SUBJECT: **NEW VEHICLE DEMONSTRATION / DELIVERY HOLD**
Safety Recall 22S73 - Supplement #1
Certain 2021-2023 Model Year Bronco Sport and 2020-2022 Model Year Escape Vehicles with a 3-cylinder 1.5L Engine
PCM Programming and Drain Tube Installation

New! REASON FOR THIS SUPPLEMENT

- Revised Technical Instructions:** A revised drain tube is now shipping, which requires a slightly different installation procedure. The revised drain tube will have a different engineering part number on the attached label. Please refer to Attachment III for additional information.
- Labor Allowances and Claiming:** Vehicle Pick-up and Delivery Allowance has been removed. Refer to EFC12071, 2023 Remote Experience Program for additional details.

FIGURE 3

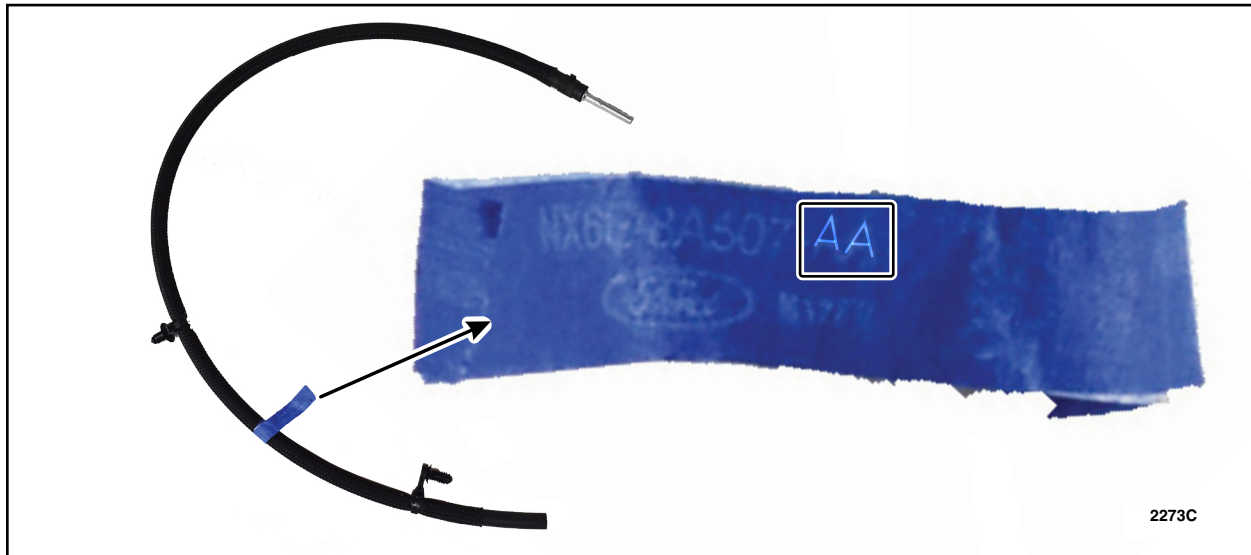
6. Inspect the part label on the drain tube. Is the suffix of the part an AA or AB? See Figure 3.
If the suffix is AA continue to Step 7.
If the suffix is AB Continue to Step 11.

FIGURE 4

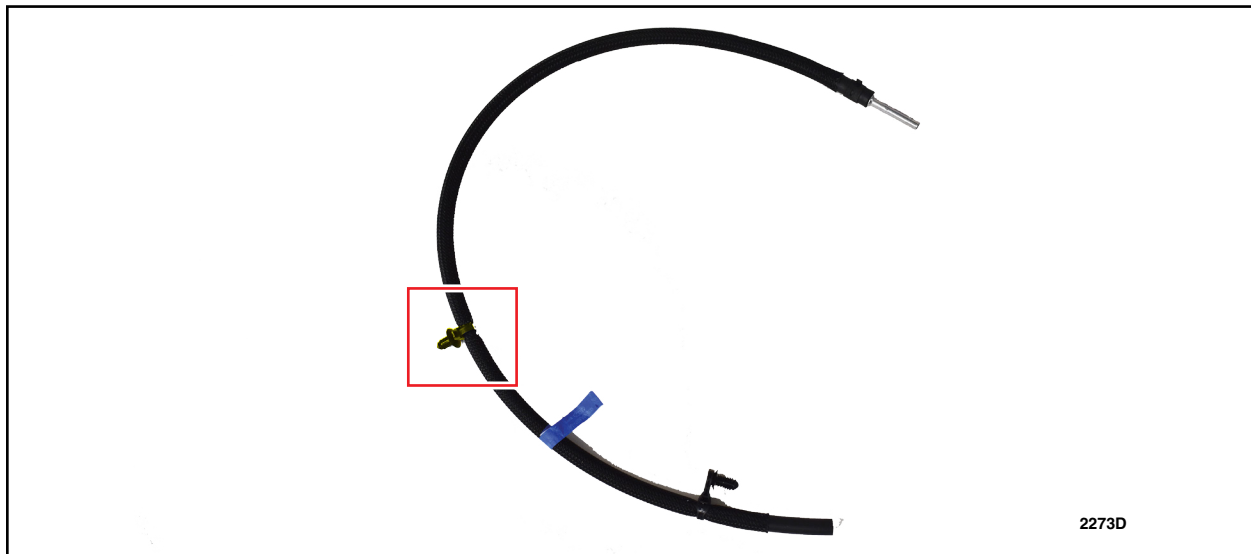
7. Remove the fir tree fastener highlighted in the figure below. See Figure 4.

FIGURE 5

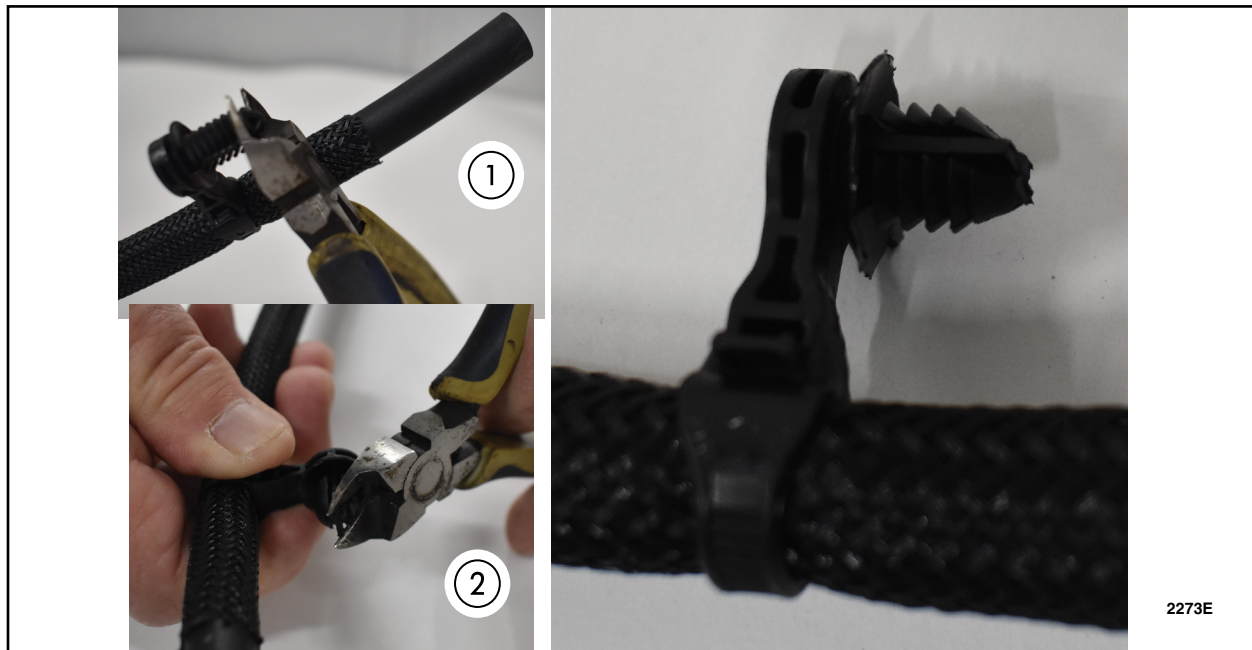
8. Cut the tip from fir tree fastener at the end of the tube. Trim the sides of the top 2 barbs at a 45-degree angle on the fir tree fastener to more easily allow fitment through the subframe hole. See Figure 5.

FIGURE 8

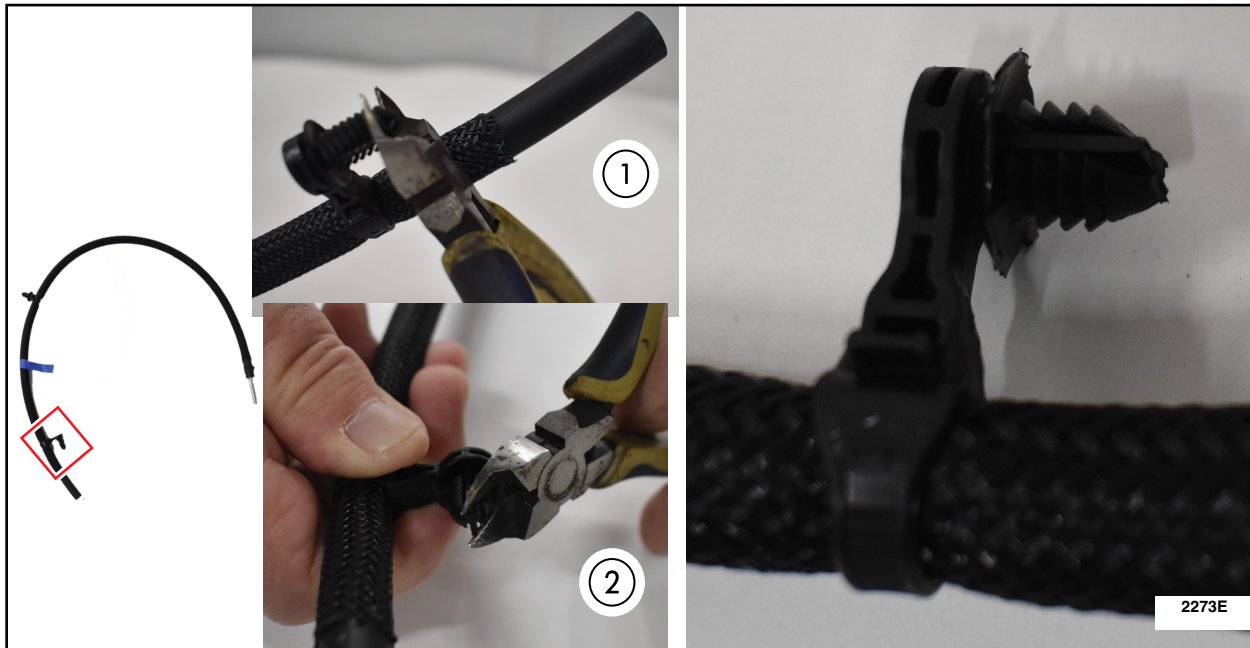
11. Cut the tip from fir tree fastener at the end of the tube. Trim the sides of the top 2 barbs at a 45-degree angle on the fir tree fastener to more easily allow fitment through the subframe hole. See Figure 8.

FIGURE 9

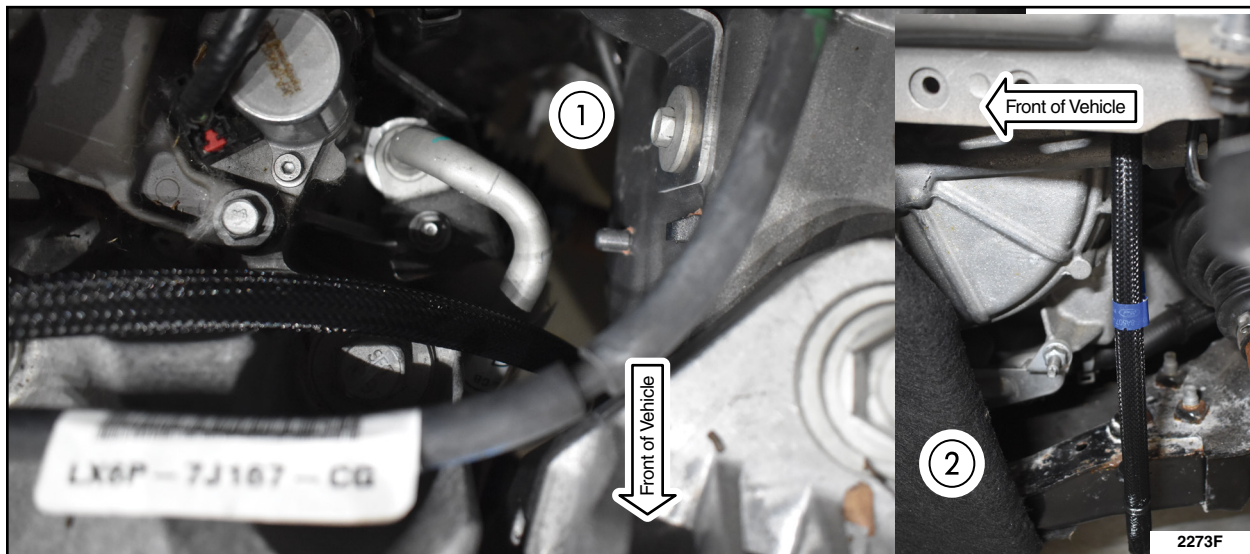
12. Feed the rubber hose end through the engine compartment and down into the wheel well. See Figure 9.

FIGURE 10

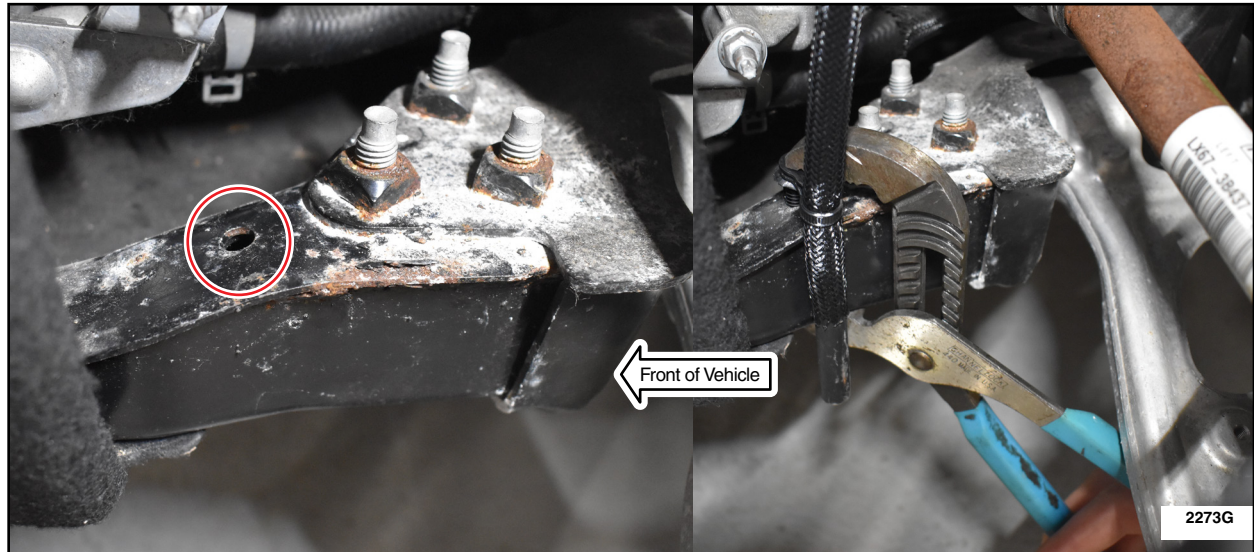
13. Attach hose to subframe. Position fir tree fastener and push in as far as possible. If needed you can use groove joint pliers to secure fir tree fastener fully into the hole in the subframe. See Figure 10.

FIGURE 11

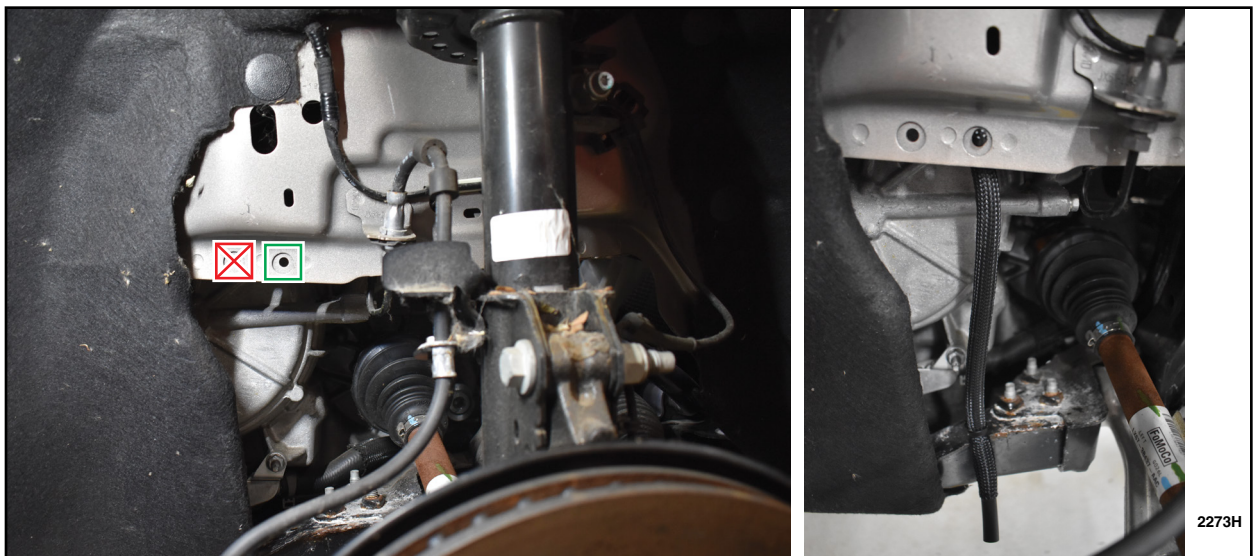
14. With the steering wheel turned to the left install the christmas tree connector as shown in the figure below. See Figure 11.
